Cumberland County Subdivision and Land Development Review Report

Municipality:	<u>Shippensburg Twp</u>	Surveyor/ Engineer:	<u>Brehm-Lebo Engineering, Inc.</u>	Owner/ Developer:	<u>Avinashi Property LLC</u>
Plat Title:	<u>Dairy Queen-Walnut Bottom Rd</u>				
Plat Status:	<u>Final</u>	Plat Type:	<u>Land Development</u>		
# of New Lots:	<u>0</u>	# of New Dwelling Units:	<u>0</u>	New Acreage Subdivided/Developed:	<u>2.43</u>
Zoning District:	<u>C-1</u>	Proposed Land Use:	<u>Restaurant</u>		
Date Received:	<u>8/31/2020</u>	County Review:	<u>9/9/2020</u>	Reviewed by:	<u>SH</u>
				Checked by:	<u></u>

FINAL LAND DEVELOPMENT PLAN FOR DAIRY QUEEN - WALNUT BOTTOM ROAD SHIPPENSBURG TOWNSHIP CUMBERLAND COUNTY, PENNSYLVANIA

PROPOSED DRAINAGE/GRADING
 FINAL LAND DEVELOPMENT PLAN
 FOR
 DAIRY QUEEN - WALNUT BOTTOM ROAD
 SHIPPENSBURG TOWNSHIP - CUMBERLAND COUNTY, PA

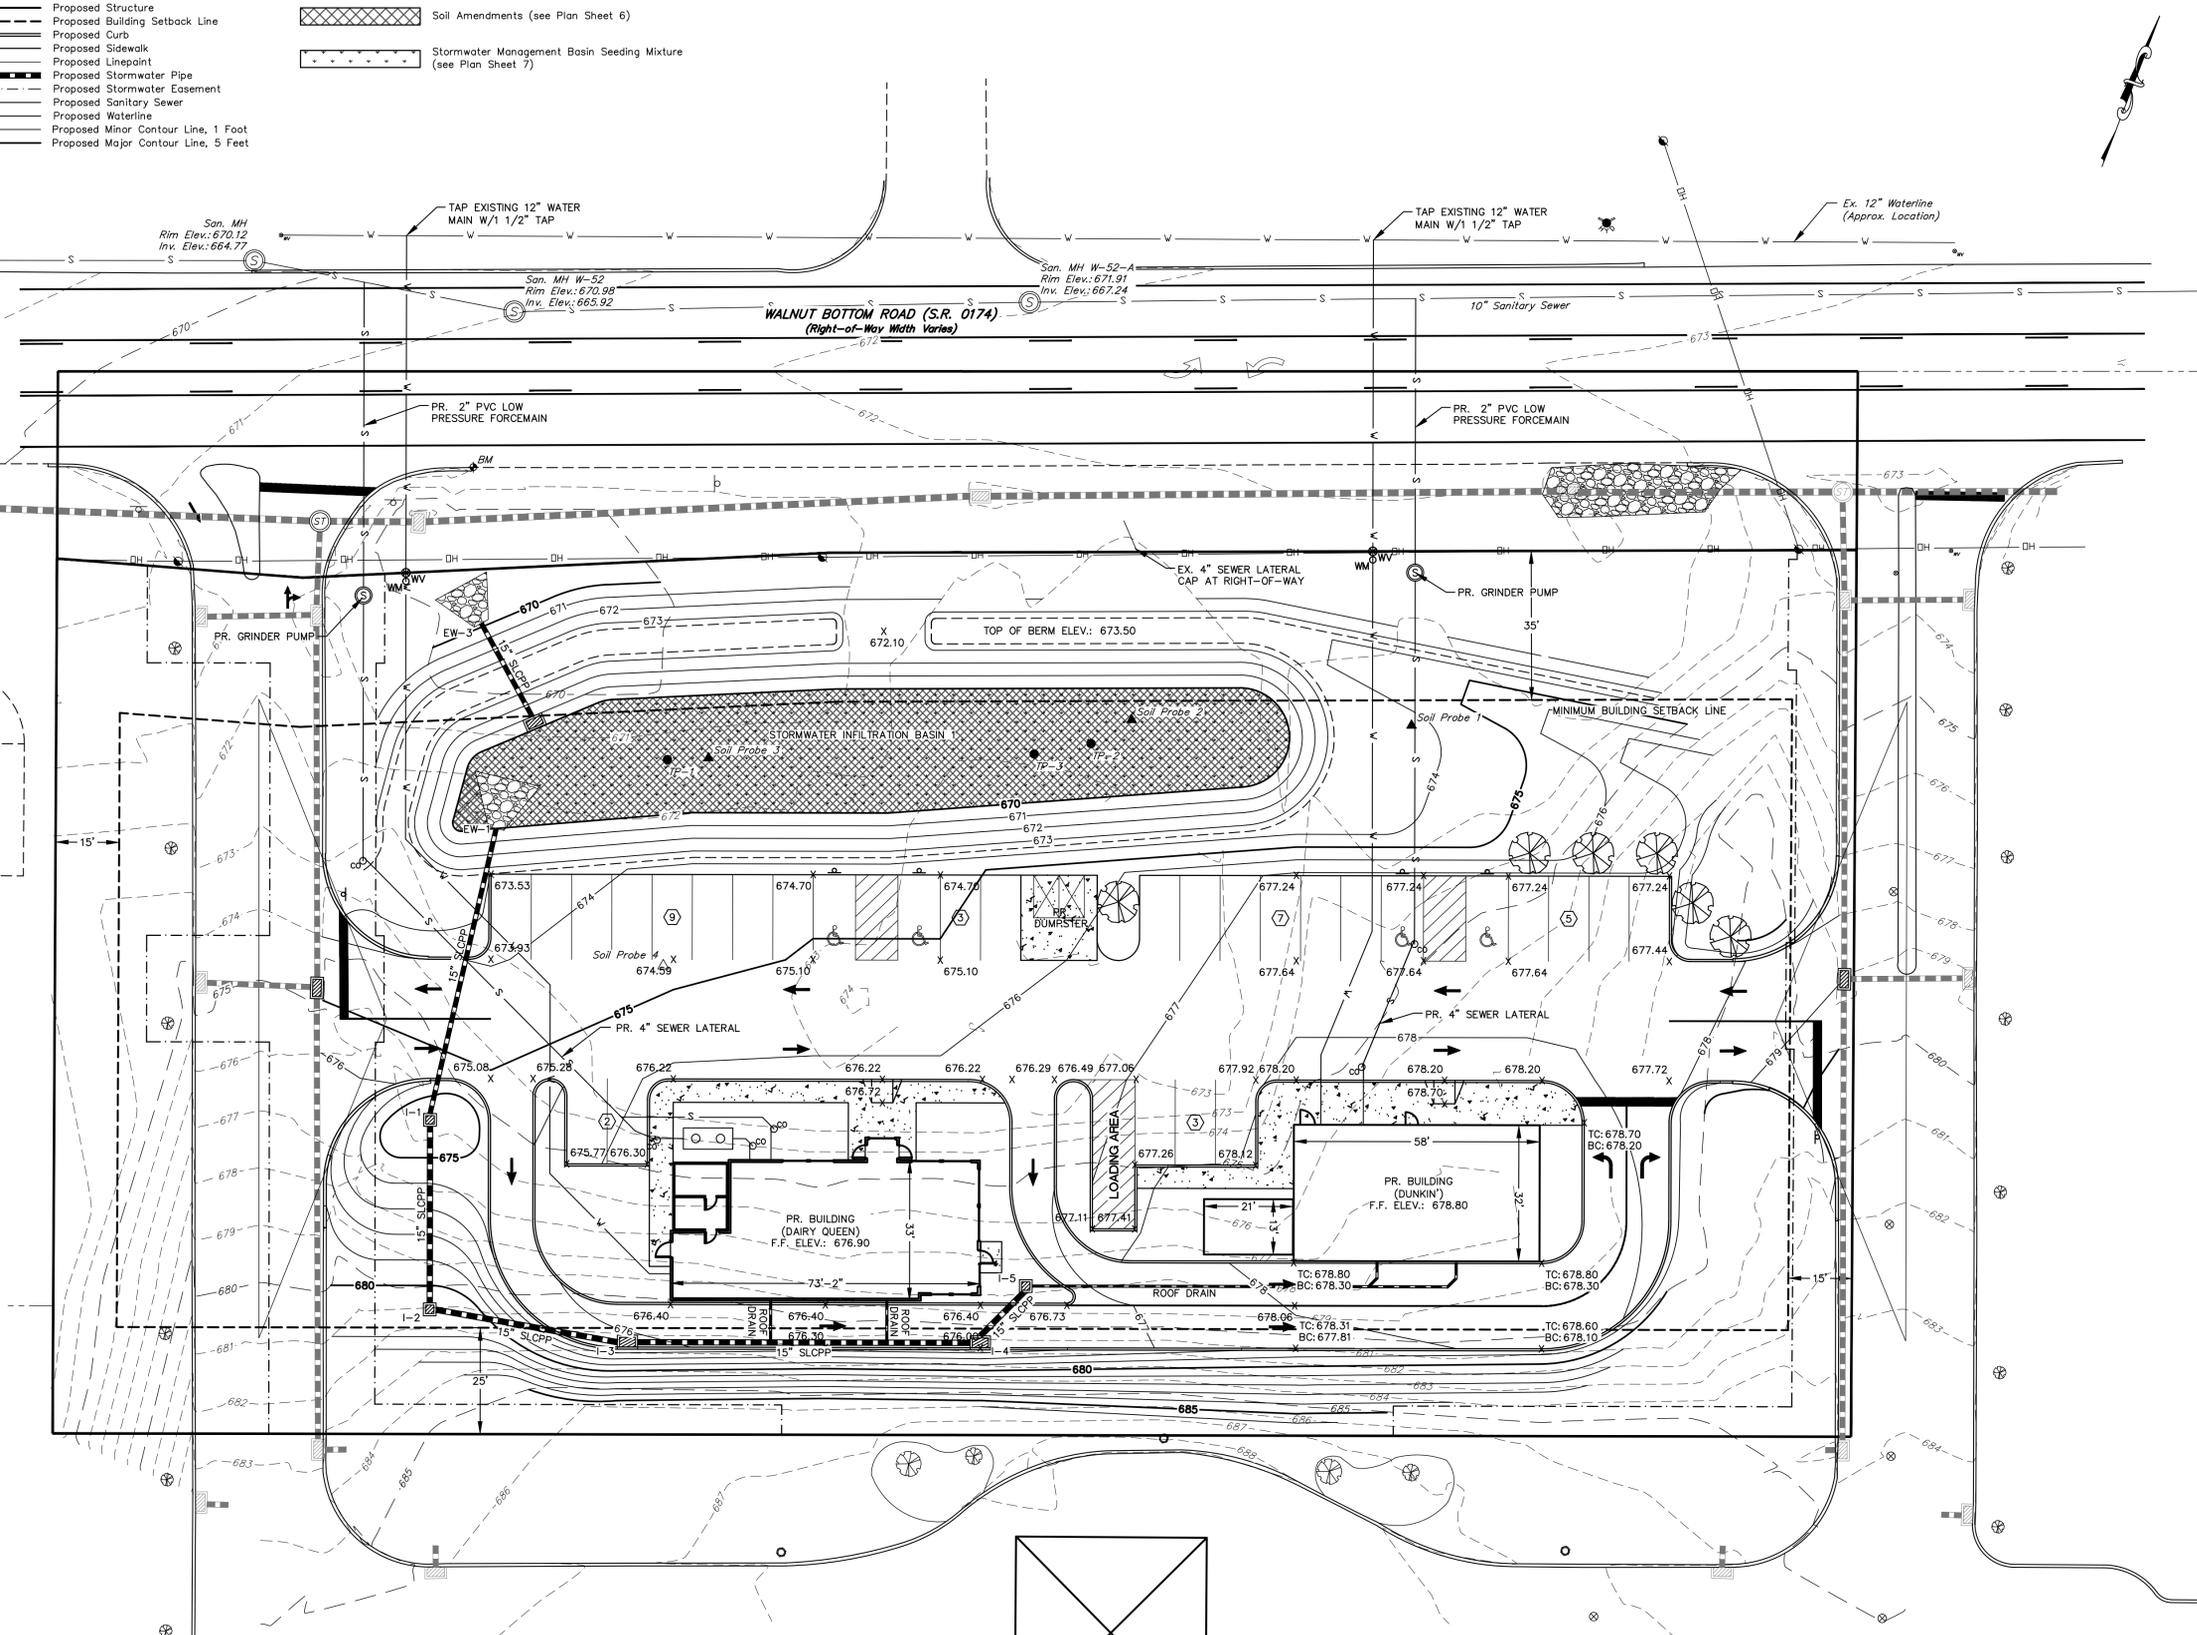
1. Clear sight triangles should be provided at all intersections (Zoning 304).
2. The plan should include the length of the proposed stacking lanes. A minimum of 160 feet is required (Zoning 342.A.9)
